HARBOR ISLE 2ND ADDITION

Re: S/D 97-59 - One-Step Final Plat of HARBOR ISLE 2ND ADDITION

**STAFF REPORT
(One-Step Final Plat)**

CASE NUMBER: S/D 97-59 HARBOR ISLE 2ND ADDITION

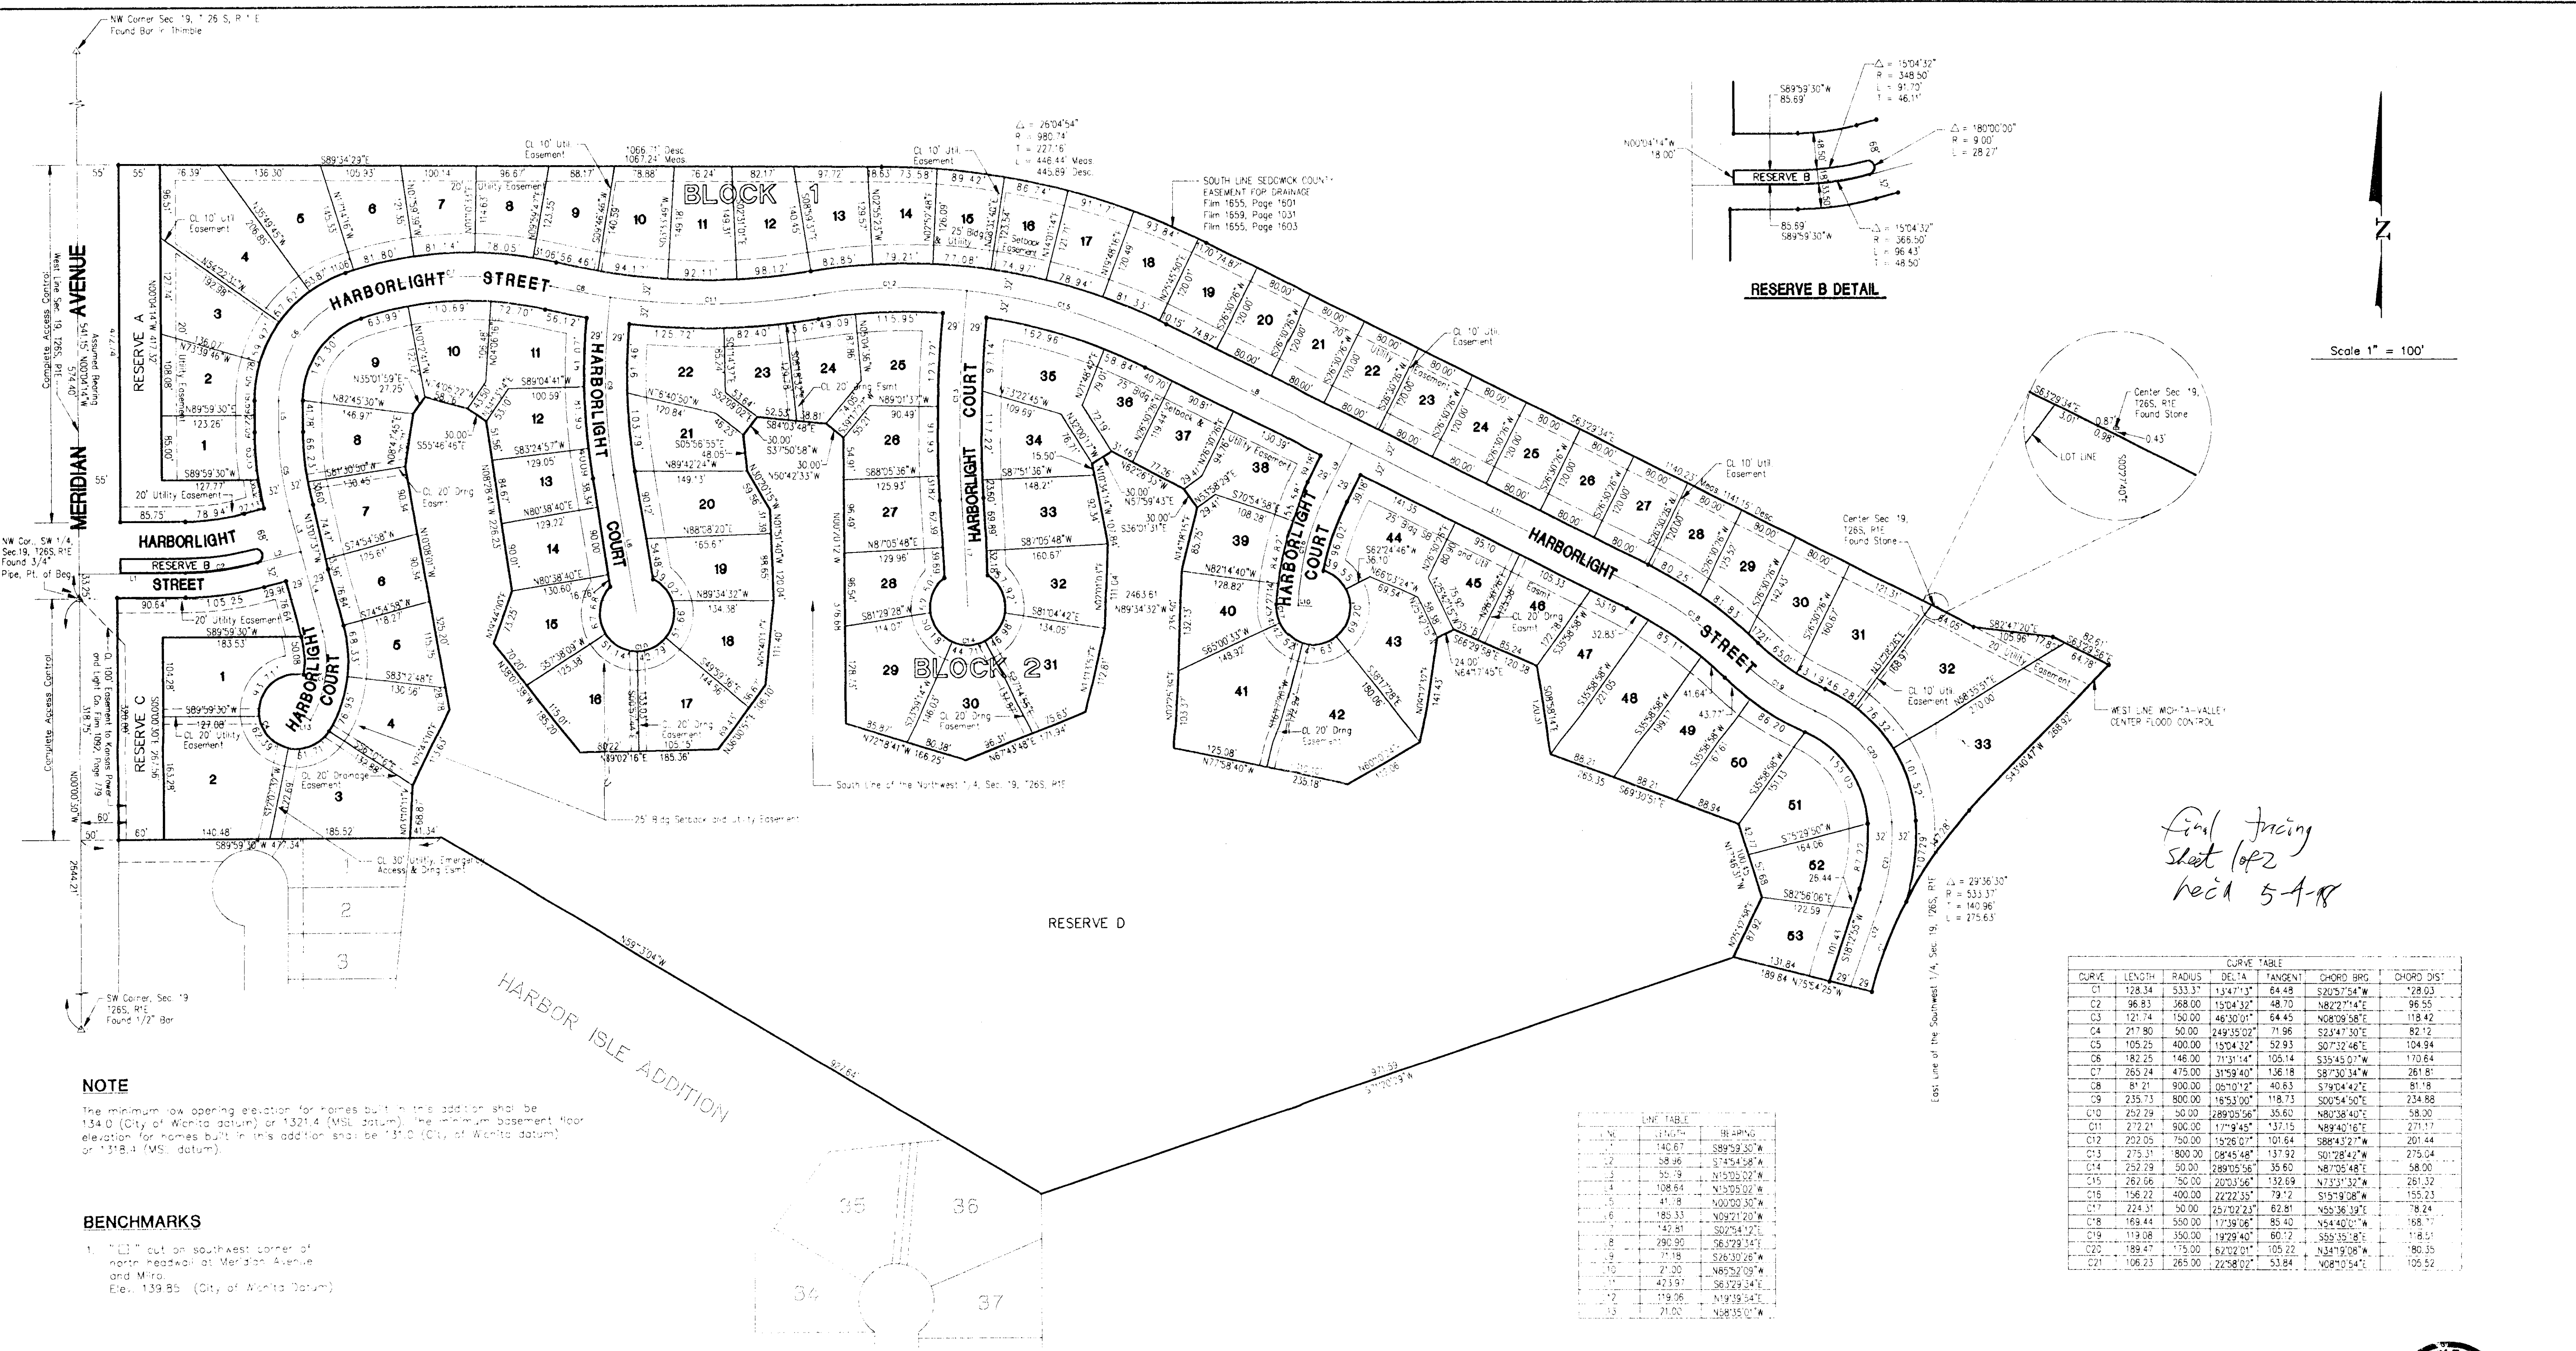
- V. The Chairman of the MAPC signature block should be amended to read Richard Lopez.
- W. In regard to the emergency access easement across lots 2 and 3 in Block 2, no obstructions will be allowed in this easement except for any gates as is approved by City Fire Department. The applicant will be responsible for the installation of an acceptable driving surface or other improvements as is determined by City Fire Department.

- X. The applicant should be prepared to comment on the need for the front yard utility easements denoted on the plat.

- Y. The applicant needs to revise the legal description to accurately portray the land being platted. The distances and degrees for the southeastern lines of the plat are not identical to the legal description.
- Z. The final plat tracing should replace references to 1997 with 1998.

- G. Traffic Engineering should comment on any improvements needed to Meridian Avenue at this time.
- H. City Engineering should comment on the status of the applicant's drainage plan as well as the minimum low opening elevations shown on the plat.

- K. Reserve D, containing the lake, adjoins Reserve F in the Harbor Isle Addition along the southwest portion of this plat which also contains the lake. Both of these reserves shall be owned and maintained by the same entity, and referenced as such in the plat's text.

- X. In regard to the emergency access easement across lots 2 and 3 in Block 2, no obstructions will be allowed in this easement except for any gates as is approved by City Fire Department. The applicant will be responsible for the installation of an acceptable driving surface or other improvements as is determined by City Fire Department.

- Y. The applicant should be prepared to comment on the need for the front yard utility easements denoted on the plat.
- Z. The applicant needs to revise the legal description to accurately portray the land being platted. The distances and degrees for the southeastern lines of the plat are not identical to the legal description.

- G. **Traffic Engineering** should comment on any improvements needed to Meridian Avenue at this time. *No improvements are needed.*
- H. **City Engineering** should comment on the status of the applicant's drainage plan as well as the minimum low opening elevations shown on the plat. *The drainage plan is approved.*

- K. Reserve D, containing the lake, adjoins Reserve F in the Harbor Isle Addition along the southwest portion of this plat which also contains the lake. Both of these reserves shall be owned and maintained by the same entity, and referenced as such in the plat's text. *The applicant shall submit a document indicating that transfer of ownership of Reserve D to the owner of Reserve F in the Harbor Isle Addition will occur subsequent to excavation of the channels.*
